**KERR-McGEE**

RE: NRC Docket No. 40-8768  
SPRB "Q" Sand Project

NRC QUESTIONS - Q-SAND LICENSE APPLICATION

NRC DOCKET NO. 40-8768

PRELIMINARY PLANT LAYOUT  
 OFFICES AND PROCESS EQUIPMENT  
 Q SAND IN SITU PILOT PROJECT  
 CONVERSE COUNTY, WYOMING

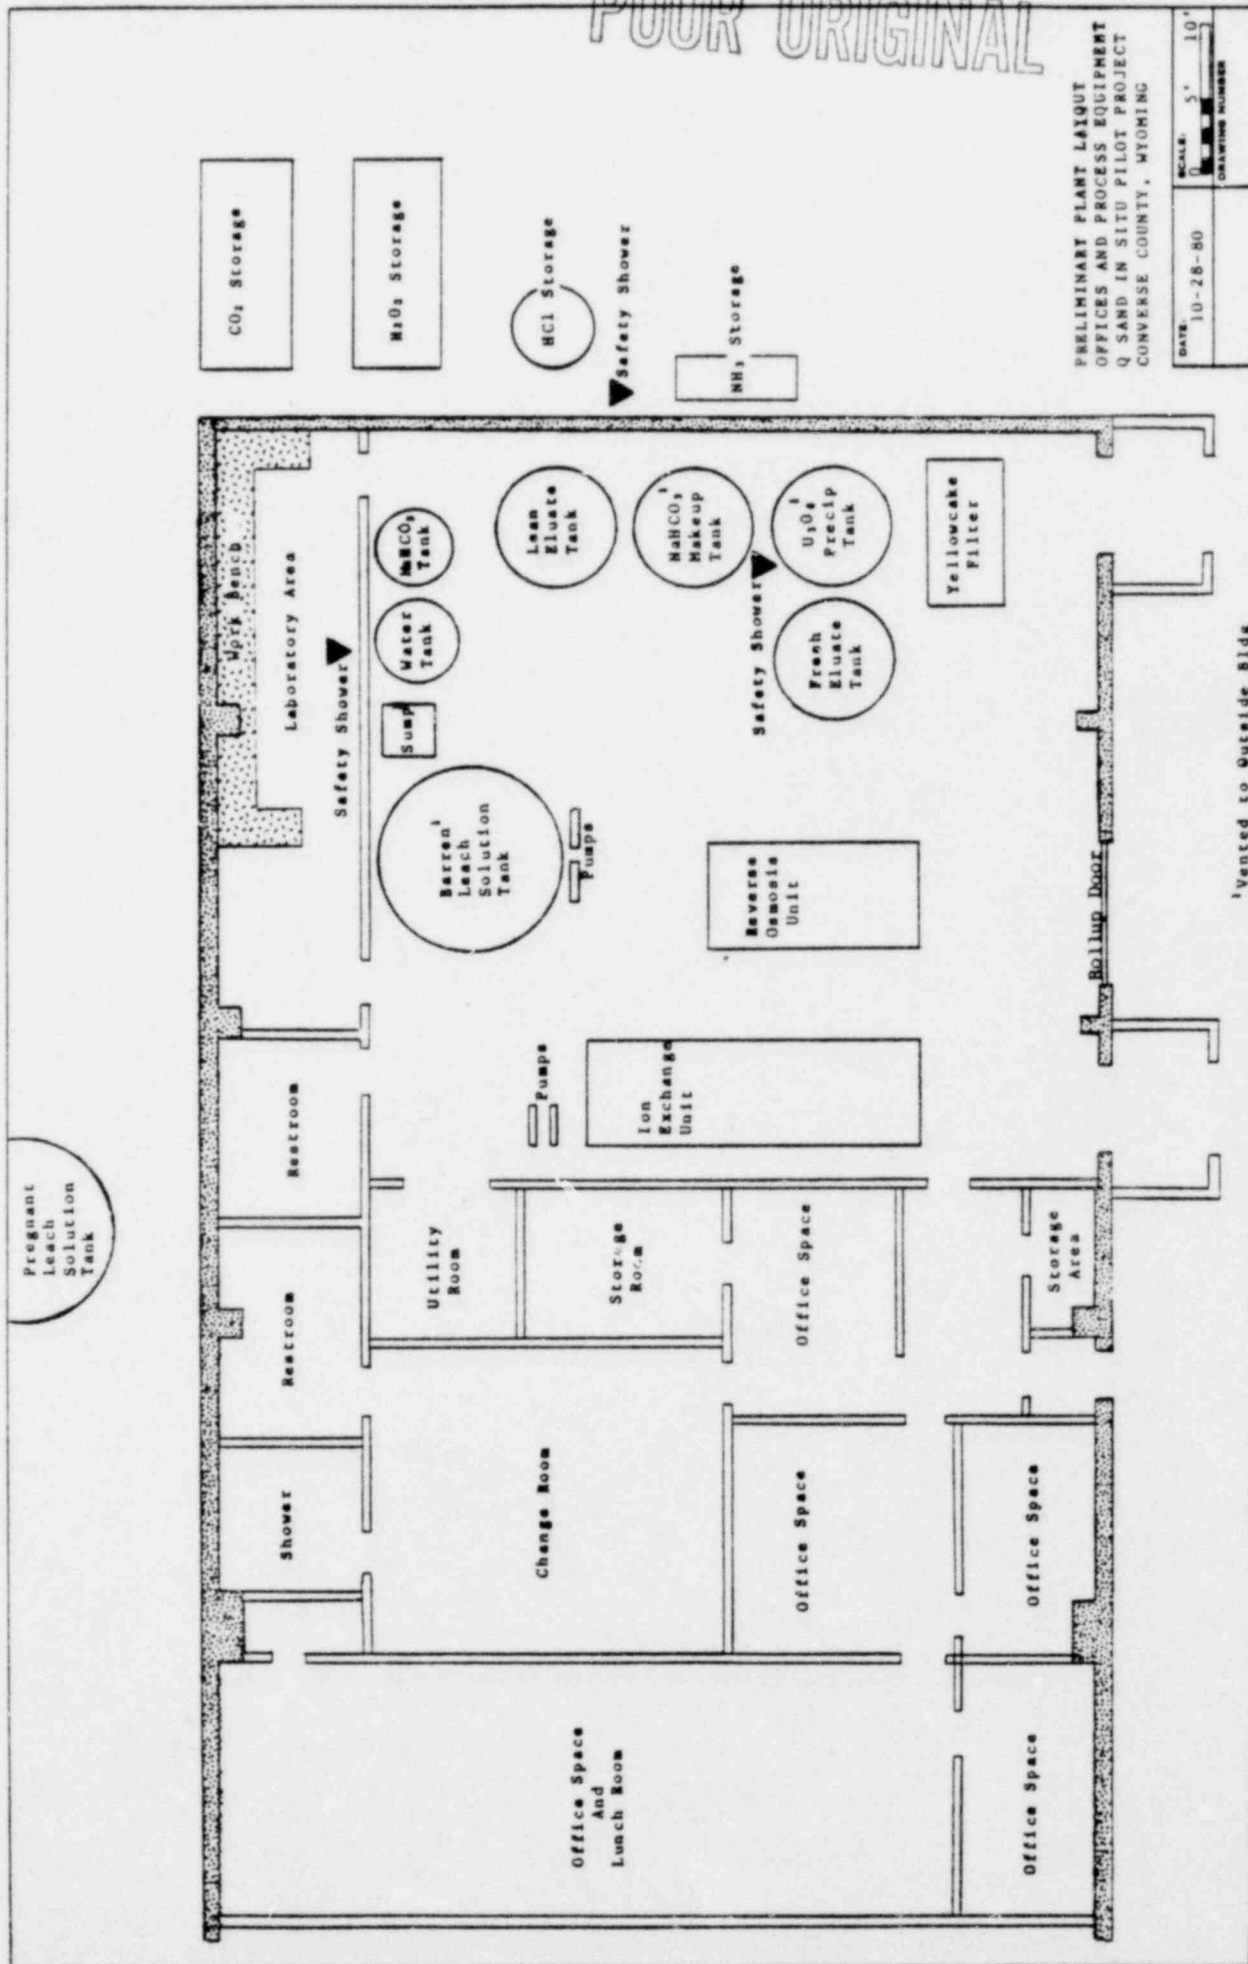
Submit a more detailed map of the process plant layout including the locations of the offices, laboratory, safety showers, and major items of equipment.

A process plant layout drawing with requested information shown is included, page A-4.

Figure 1  
LOGS OF EXPLORATORY HOLES  
POND SITE #2

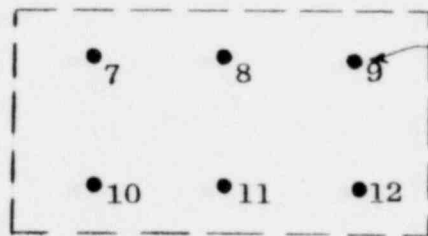
For the evaporation pond, the following information is needed: (1) the approximate amount of earth to be moved, (2) pond capacity (3) anticipated

thickness of the liner, (4) designed freeboard, (5) anticipated water elevation above mean sea level, and (6) a preliminary soil stability analysis.

The site recommended by the consultant is located about 500 feet northwest of the Bill Smith mine office building. The soils in this area are medium stiff to stiff, slightly sandy to very sandy clay with minor clayey sand lenses to the depth investigated, 15 feet. The consistency of the sandy clay was determined by the Standard Penetration Test. Test results are presented in Figure 1, page A-5. Gradations for typical samples of the sandy clay are presented in Figure 2 through 4, pages A-7 to A-9. No free water was encountered in the exploratory holes at the time of drilling.
